NOTICE OF VIOLATION

On February 3, 2025, Energy Safety conducted an inspection of Southern California Edison Company's WMP initiatives in the vicinity of the city of Tehachapi, California. The inspection report is enclosed herewith. Energy Safety found the following violation(s):

Violation 1. Energy Safety observed that in implementing 2024 WMP initiative 8.1.3.1 - Distribution Detailed Inspections Remediations (IN-1.1), SCE failed to complete remediation of the loose transformer hanger bolt on Pole ID 1898072E, Grid Hardening ID 414080465-1898072E, at coordinates 35.142054, -118.512856. Energy Safety considers this completeness violation to be in the Minor risk category.

Figure SL 515–7: 6.6 "A" RO Transformer — 33 kV–2.4 kV (Using RCOC Switch)

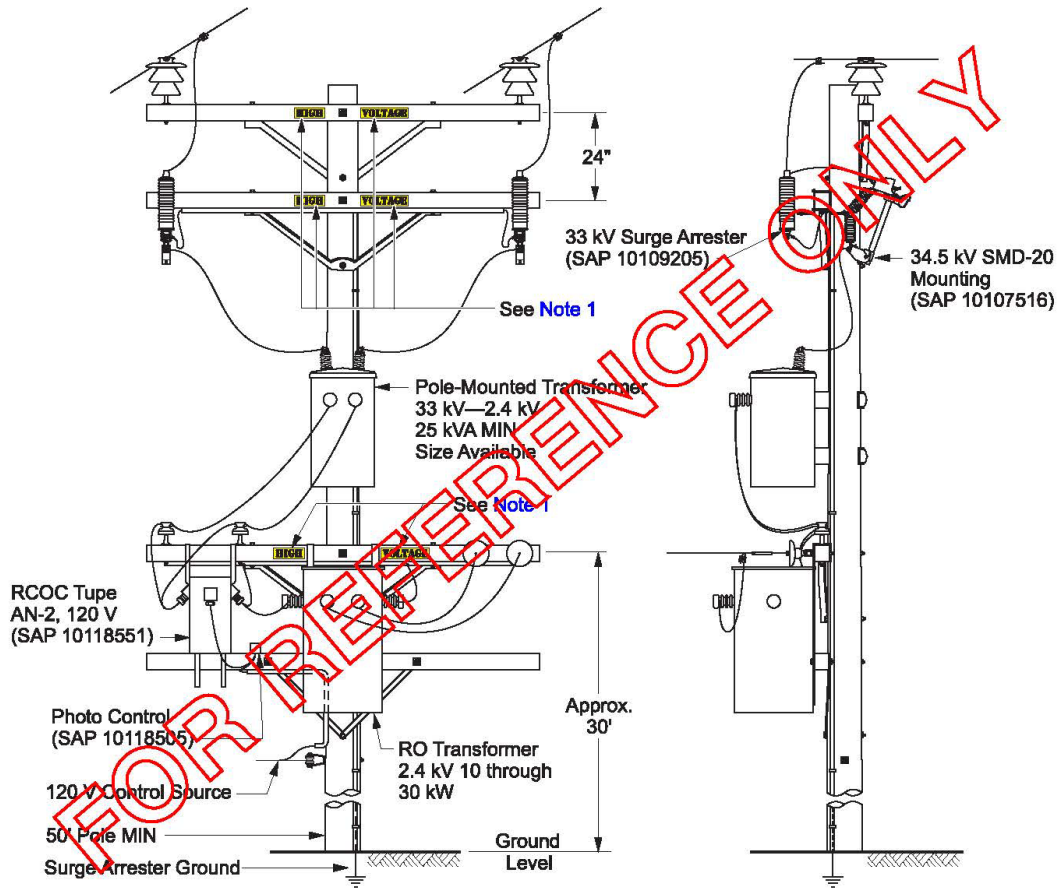
1. Southern California Edison Company's 2024 WMP 8.1.3.1 Distribution Detailed Inspections and Remediations work, remediation of a loose transformer bolt was reported complete at this location.
2. The transformer is loose, and the top hanging bracket is not flush with the pole.
3. SCE Distribution Construction Standard SL-515 (sheet 8 of 8) depicts a side profile image of a pole mounted transformer, and demonstrates proper installation of top and bottom hanging brackets that are flush with the pole.⁹
